INDESIT company

Model type:
BAAN12FR

Commercial code:
F044462

Notices

N1030093fig1

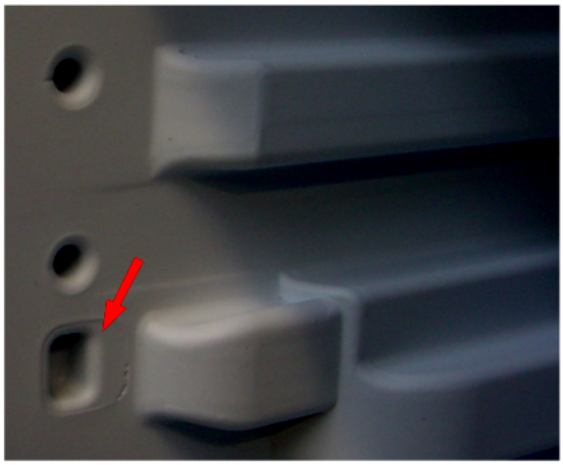
n1030093: New fixing of evaporator on static fridge-freezers (05 range) 60 cm,Melano

From August 05 (serial no. 50802.0001) the freezer evaporator is secured to the cabinet by a plastic profile.
The cabinet walls have been modified to create locations to house the profile, which is installed on the front of each evaporator plate (see photo N1030093fig1- fig2 - fig3)
The profile cannot be fitted on premodification appliances, so technical personnel must continue to fit the rh and lh supports on these models (see photo N1030093fig4)

New parts
C00141135 = WHITE PROFILE L=443.5 MM

Parts replaced
C00075596 = EVAPORATOR RH SUPPORT
C00075597 = EVAPORATOR LH SUPPORT
